FUEL RECOVERY OPERATION/WOOD RIVER JUNCTION, R. I. 02894

RG 79 - 2
January 4, 1979

FRO is presently undertaking a construction project in the vicinity of the lagoon area on the east side of the protected area.

UNC/FRO PLANT LAYOUT

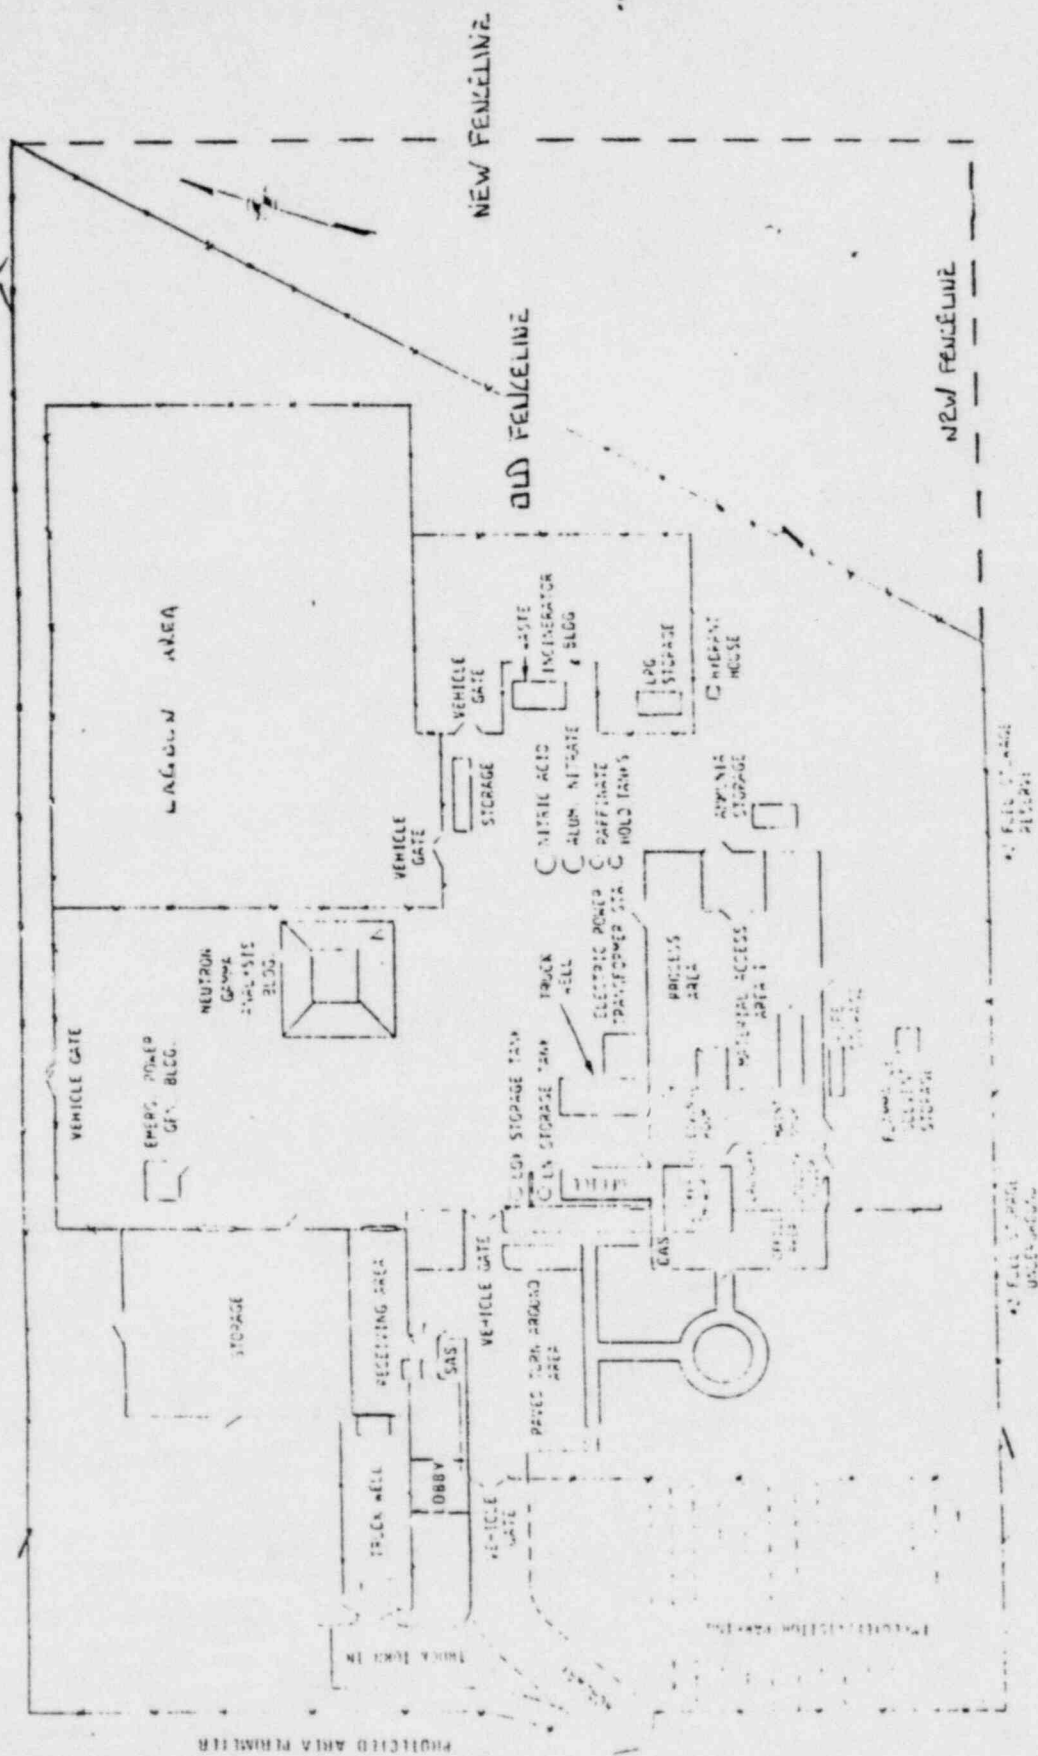
The east and a portion of the south perimeter fence will be altered to accommodate this construction. The southeast corner of the protected area barrier will be moved approximately 45 feet eastward, which will square-off the east protected area barrier.
